## A. Proposal for amendments to UN Regulation No. 107

Annex 12

Paragraph 3.10.12., amend to read:

On the Figure is AIR GAP and LARGE DISTANCE the Reinforced insulation.

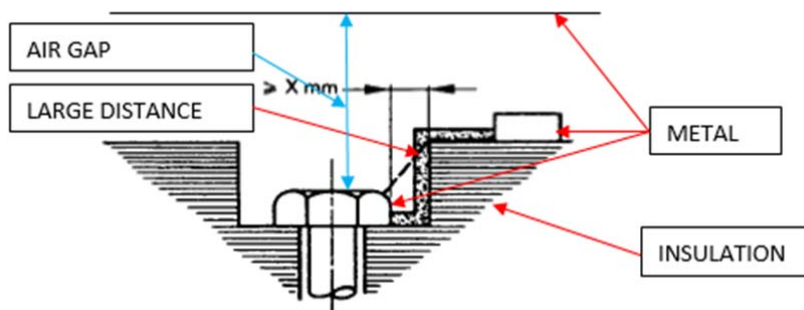
~~Reinforced insulation in trolleybuses is not allowed for circuits directly connected to overhead line~~

**Circuits directly connected to overhead line shall be double insulated.”**

1) Reinforced insulation is used ordinarily on the many places in the double insulated system, just for example – when inside of the metal box of inverter is a power screw terminal and between screw and metal lid is air gap with large distance – this air gap is Reinforced insulation.
